**Request for further information in accordance with section 92 of the Resource Management Act 1991**

**Notices of requirement:** Eastern Busway EB3C (Auckland Transport)  
Eastern Busway EB4L (Auckland Transport)

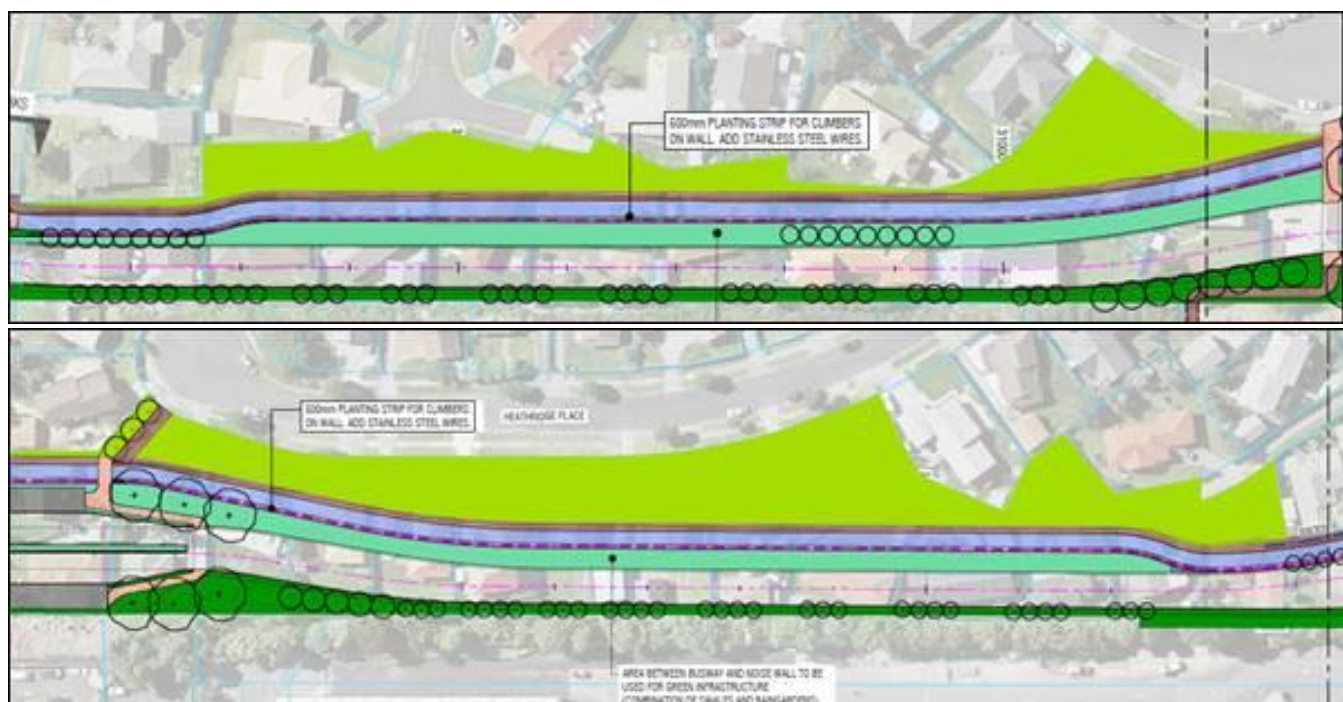
*SI 12 Please provide an assessment of the operational Construction noise for residences.*

Whilst it is acknowledged that residences in direct proximity to the works on Guys Reserve and Whaka Maumahara (notably 47 Huntington Dr, Saidia Pl, Cottesmore Pl, Kiriki Ln, Waihi Way) are yet to be engaged specifically, the SIA needs to provide further information regarding the consideration of potential social impacts of construction noise. For example, the construction methodology notes vegetation removal, earthworks, bridge building and other noisy works that need more consideration by the SIA.

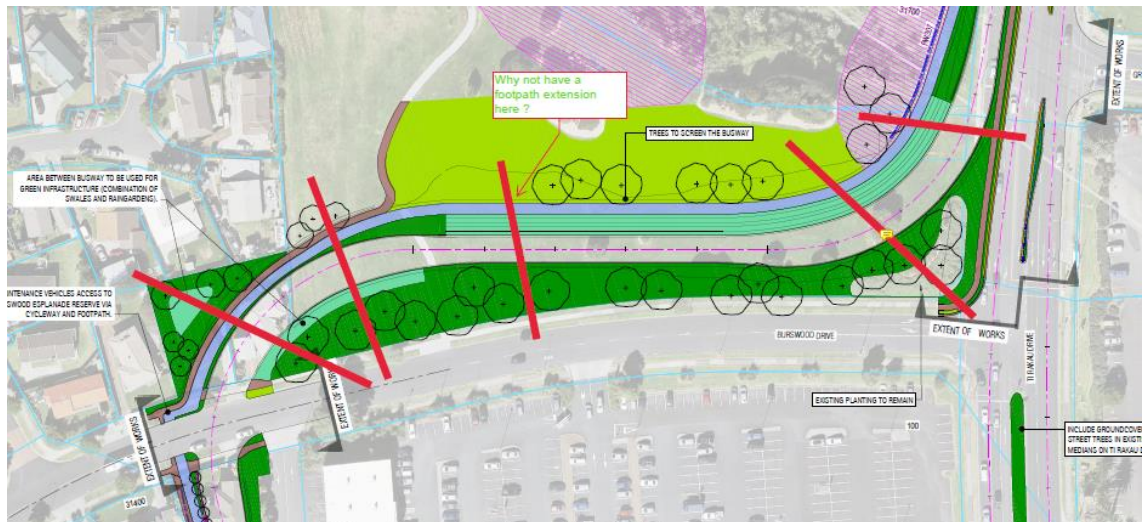
**UD8** *Please provide proposed section plans as indicated by red lines in image below.*

This will allow for an understanding of effects of the interface and visibility of the proposal from public locations.
